## ROUND 2 PROPOSED REVISIONS FORM INTRODUCTION

## Issue 1 – Length Definition

### 1.a General Length Definition (SLF 53/5, annex 4, issue No. 1)

**3.i Revolving Door Within a Covered Space (Italy)**

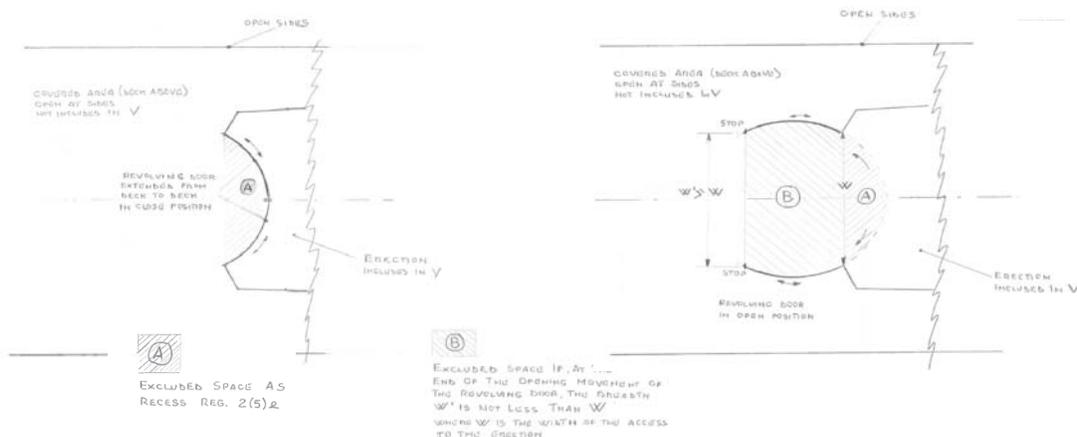
**Description of Issue** In applying excluded space provisions to a revolving door assembly that is within a covered space open on the side, it is unclear as to whether the door assembly itself is considered to be a partition that bounds enclosed space, or otherwise affects the exclusion of the surrounding space. In this case, the assembly extends from deck to deck. Figure A (left) shows the revolving door in the closed position. Figure B (right) shows the revolving door in the open position, effectively creating the new space B, which covered and protected on its sides.

**Round 1 Proposals** The group considered a single proposal, recommending that if the breadth ( $W'$ ) at the maximum opening movement of the revolving door assembly is not less than ( $W$ ), the width of the access to the erection, the spaces A and B are not included in tonnage, assuming that the doors are not portable partitions or bulkheads.

**Round 1 Questionnaire Responses** A majority of respondents disagreed with the proposal, with one respondent expressing the view that the doors are, in fact, partitions. Another took issue with the characterization of A as a recess in a boundary bulkhead, expressing the view that the door assembly does not constitute a bulkhead. This respondent provided a history of development of the language at the TM Convention, observing that the adjective “portable” originally applied only to the word “partition” with “bulkhead” added later, and commenting that it remains unclear as to whether the adjective applies to both bulkheads and partitions. One respondent agreed with the exclusion of A but not B, as B extends into the deckhouse in excess of the one half the breadth criteria, which equals  $W$  in this case.

In the following figures: O = excluded space  
 C = enclosed space  
 I = space to be considered as an enclosed space  
 Hatched in parts to be included as enclosed spaces.

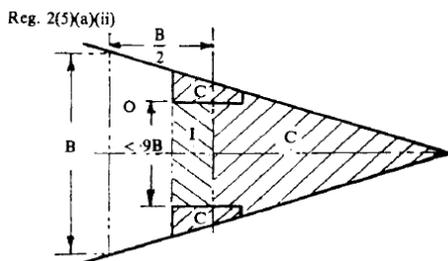
**Description of Issue** The TM Convention is inconsistent in how it describes and treats spaces that are “excluded” from tonnage. The Convention states, in effect, that “excluded” means “excluded from the total volume of all enclosed spaces (V)”. However, associated figures indicate that “excluded” means “not enclosed”. It appears that the labeling in the figures (“O” (for “Open”), “C” (for “Closed”) and “I” (for “Included”)) derive from that used in Proposals A & C discussed at the 1969 Tonnage Conference, which eventually became the basis for the gross tonnage measurement of the Convention, but which did not use the term “excluded”.

**Round 1 Proposals** The group considered two proposals. One proposal recommended establishing the interpretation that an excluded space is an enclosed space in all cases, and revising the Appendix 1 figures accordingly if the TM Convention is amended for other reasons. A second proposal recommended, if there is agreement, to amend the TM Convention with a broader definition with details on how to identify and address excluded spaces, knowing that in all cases such space are “indoors” (enclosed).

**Round 1 Questionnaire Responses** A majority of respondents agreed in principle with the first proposal, with one commenting that the matter could be satisfactorily treated through interpretations and other suggesting specifically the term “excluded” be interpreted as “enclosed but excluded”. Most agreed with the second proposal, with no disagreement, although two respondents expressed preference for addressing the matter through interpretations. Another participant expressed the view that an interpretation cannot supersede a provision of the TM Convention, and that the text and figures in the Convention need to be amended accordingly.

**3. k Mobile Cranes (CG Round 1)**

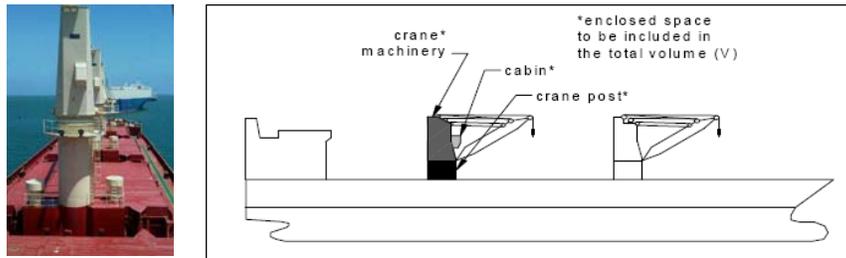
**Description of Issue** A clear definition of the term “mobile” should be given, as the term, as it is, leads to misunderstanding. A generally-accepted definition of mobile crane is one that is easily moved from one location to another. On cranes like the one shown in the picture below, the upper part rotates in its own axis; it does not actually “move” from its location so should be included in the total volume of all enclosed spaces (V).

**Round 1 Proposals** The group considered a single proposal. The proposal recommended that only those cranes of a type which displace from one point to another (e.g., gantry cranes) should be exempted.

**Round 1 Questionnaire Responses** There was little agreement on the proposal. A respondent who agreed, with changes, recommended establishing a detailed definition of mobile crane along the lines of a machine mounted on a non- or self-propelled, crawler- or wheel-mounted, mobile base, that is capable of travelling over a supporting surface without the need for fixed runways. One respondent who disagreed commented that machinery, meaning revolving cranes, movable loading/unloading equipment and other similar items or structures, should not be included in tonnage. Another expressed the view that crane structures, regardless of type, should be included in tonnage. Another questioned why the term “mobile crane”, rather than a more generic term, is used, citing the example of spreader beam for a heavy lift ship, which is portable, but stowed on deck.

**3. m Spaces Fitted to Outer Structure Boundary (CG Round 1)**

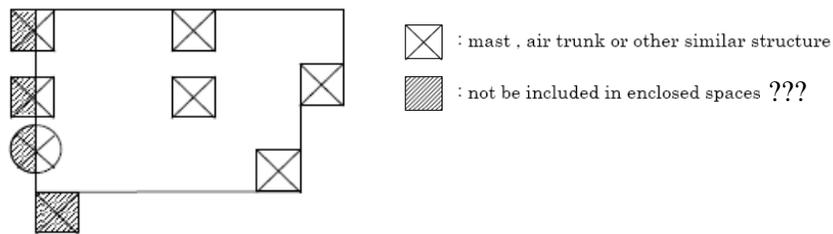
**Description of Issue** Clarification is required regarding treatment of the part of the mast, air trunk and other similar space fitted to the outer surface of a structure’s boundary.

**Round 1 Proposals** The group considered a single proposal. The proposal recommended that the part of space fitted to the outer surface of structure’s boundary having at least three exposed sides and having the largest cross-sectional area in the longitudinal direction of the structure not exceeding 1m<sup>2</sup> should not be included in tonnage.

**Round 1 Questionnaire Responses** An equal number of respondents agreed, or agreed with changes, as disagreed with the proposal. Three respondents commented that per the paragraph 4.6 interpretations of TM.5/Circ.5 (regulation 2(4)), spaces not separated on all their sides should be included in tonnage. Another respondent expressed preference for removing the sectional area criterion from the existing interpretations altogether to avoid impacts on ship designs, but recommended that the proposal should be modified to take the cross sectional area in a direction perpendicular to its longitudinal axis, should this view not prevail.

**Issue 4 – Definition of Deck, Cover and Partition****4.d Fitting of Grates Over Side/End Openings (CG Round 1)**

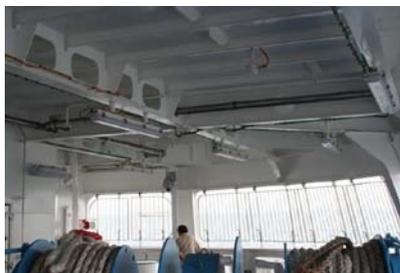
**Description of Issue** Due to different reasons (not the least of which are concerns over piracy), it is becoming more frequent to see the fitting of grates and similar devices fitted at external openings. to provide a barrier against intrusion. The picture below provides an example of this kind of arrangement.

**Round 1 Proposals** The group considered a single proposal, recommending that the presence of grates that are fitted at side or end openings for spaces should not be considered a means of closure when applying the provisions of regulation 2(5).

**Round 1 Questionnaire Responses** Most respondents agreed with the proposal. In agreeing, two respondents expressed the view that this issue should probably be addressed in the TM Convention if amended for other reasons, with one commenting that the fitting of such gratings effectively does not protect spaces from the sea or weather, and was probably not envisioned at the time when the TM Convention was developed. Another respondent noted that, while not directly a tonnage matter, consideration should be given how such gratings impact the means of escape through the opening in case of emergency.

**4.e Fitting of Grates Over Deck Openings (CG Round 1)**

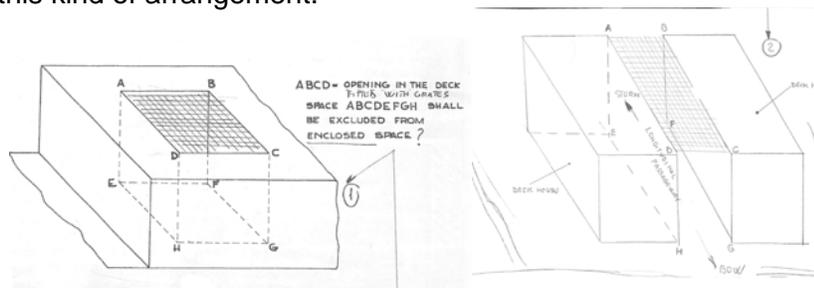
**Description of Issue** Spaces that can be excluded in accordance to the Regulation 2(5)(d), are frequently fitted with grates (e.g., in order to allow crossing). Also longitudinal passageways between deck houses are sometimes fitted with grates on the top. The following figures provide examples of this kind of arrangement.

**Round 1 Proposals** The group considered a single proposal, recommending that the presence of deck grates provide a means of closure under regulations 2(5)(d), and therefore would preclude any space below from exclusion from tonnage.

**Round 1 Questionnaire Responses** There was little agreement on the proposal. One respondent agreed that a grating could constitute a means of closure, such that the space ABCDEFGH in the left hand figure cannot be excluded, but that a grating is not a deck, and therefore the space ABCDEFGH in the right hand figure is not an enclosed space. Two respondents expressed views along the lines that grates may not constitute partitions or decks, and if this is the case, the presence of a deck grate should not cause the space below to be included in tonnage. Another respondent commented that the presence of grates whose only purpose is to provide safe access and prevent risk of injury to crew members should not change the status of the space.

**5.f Restrictions on Excluding Space Below Uncovered Openings (SLF 53/5, annex 4, issue No. 20)**

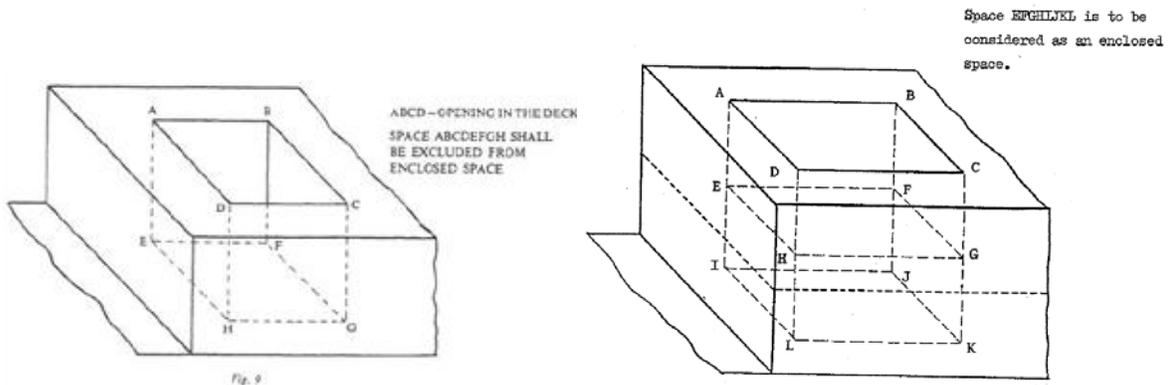
**Description of Issue** The text of Regulation 2(5)(d) and the accompanying figure leave it unclear as to the extent to which a space “immediately below” a deck opening may be excluded. A question along these lines was raised by a flag State in document SLF 29/10 (3 November 1983), but was not resolved.

**Round 1 Proposals** The group considered six proposals. Two proposals made recommendations along the lines of defining “immediately below” as extending to the next complete structural deck underneath the deck with the opening, with both indicating the need for a definition of “structural deck”, and one recommending inclusion of a supporting diagram. One proposal recommended that the space lettered ABCDEFGH should be construed as “immediately below”, while another, citing discussions at SLF 29, recommended that the space lettered ABCDLIJK should be similarly construed. Another proposal recommended establishing the interpretation that “immediately below” means to a depth not exceeding the distance to the deck below, or one-fourth the breadth of the ship, whichever is less. Another simply recommended better documentation.

Figure 1: A ship fitted with spaces between the inner skin and the outer shell to fill air for buoyancy

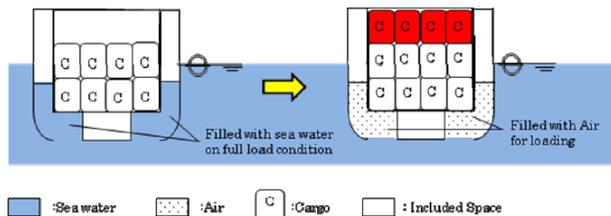
**Description of Issue** Some ship designs have been developed to obtain additional buoyancy or an additional cargo capacity with no increase in the gross tonnage, making use of the open to the sea provisions regulation 6(3) to effectively reduce the ship's gross tonnage. Examples of such designs are: 1) ships with open bottom spaces between the inner skin and outer shell to hold air to gain additional buoyancy (figure 1); and 2) ships with cargo spaces between cross-deck structures with gratings openings to the sea (figure 2). The volumes of such spaces can be substantial relative to the total volume of the ship.

**Round 1 Proposals** The group considered four proposals. Two proposals recommended the interpretation along the lines that spaces open to the sea, used or appropriated for holding cargo, and/or contributing to the buoyancy of the ship should be included in tonnage. One proposal recommended the interpretation that the space must be in free communication with the sea at all times. The remaining proposal recommended that tonnage not be calculated with respect to the use of a space, but that spaces that are not always open to sea or are fitted with a means of securing cargo cannot be excluded.

**Round 1 Questionnaire Responses** Most respondents either agreed with all of the proposals, or agreed subject to changes. In commenting on the proposal regarding free communication with the sea, one respondent cautioned that the language must address stern chutes and hawse pipes. Another respondent stated agreement in principle with this proposal, subject to including the provision that a space open to sea may not be excluded if used for the carriage of cargo, and noting that this approach would address situations where trapped air could prevent water from entering a tank. Another participant expressed the view that there should be no linkage between exclusion of a space as open to sea and whether or not the space is buoyant or carries cargo or stores.
